# SERVICE BULLETIN

Service Bulletin No.: DA20-79-08 Rev 2

Title: Introduction of a new Oil pressure Indicator

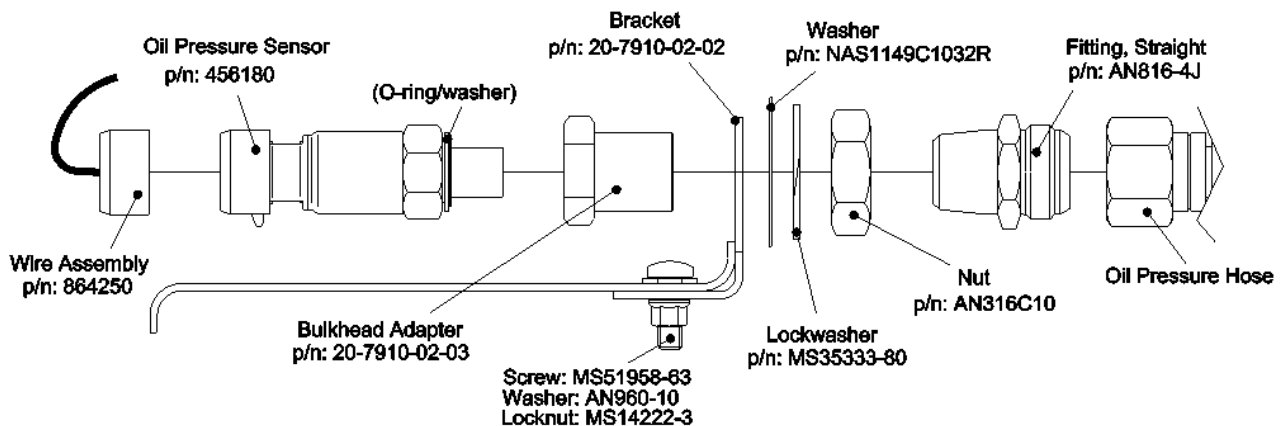
**11.1.2** Installation of new oil pressure sensor (P/N: 456180) and wire assembly (P/N: 864250):

**NOTE:** On aircraft serial number 10145 and subsequent, or aircraft in compliance with Service Bulletin DA20-79-01 revision 1, or earlier (located on the Aft RH engine compartment). Install as shown in the Figure on Page 3.

**11.1.2.1.1** Install the oil pressure sensor (with o-ring/washer) and fitting (P/N: AN816-4J) to Bulkhead adaptor (P/N: 20-7910-02-03) with Loctite 243.

**11.1.2.1.2** Torque the oil pressure sensor to 15Nm (98 in.lb) (maximum).

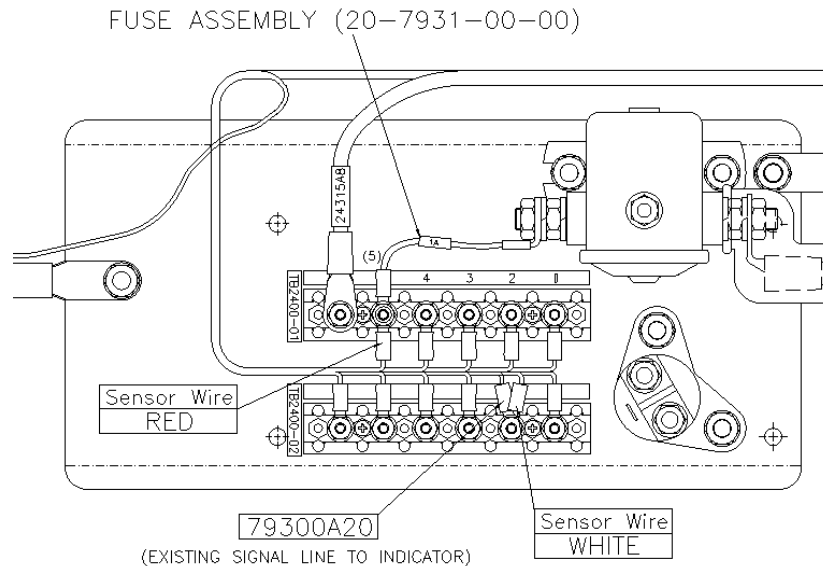
- 11.2.2** Crimp ring terminals (P/N 36151) to RED and WHITE Sensor wires.
- 11.2.3** Connect the new oil pressure sensor wire assembly to the electrical shelf as shown in table below.
- 11.2.4** Install Fuse Assembly (P/N 20-7931-00-00) from the battery relay to terminal block post #5 as shown in the Figure on Page 4.

Sensor Wire Assembly (P/N 864250)	Location
RED	TERMINAL POST #5 on Terminal block TB2400-01
WHITE	TERMINAL POST #2 on Terminal block TB2400-02

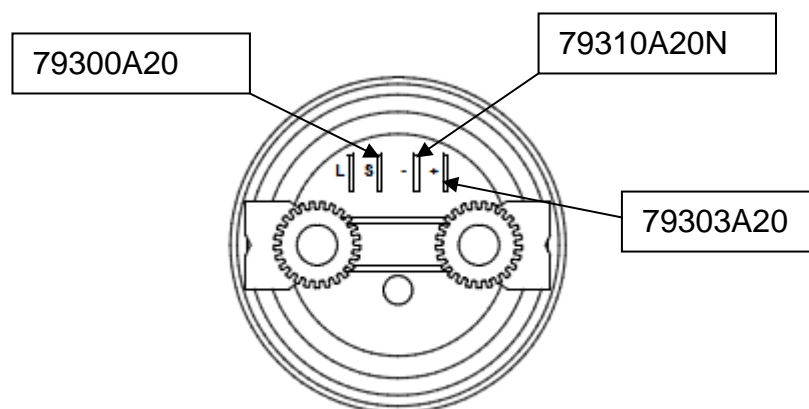
11.3.3 Install Oil Pressure Indicator (P/N 20-7930-00-00).

11.3.4 Secure wires 79303A20, 79310A20N and 79300A20 to the Oil Pressure Indicator as shown below.
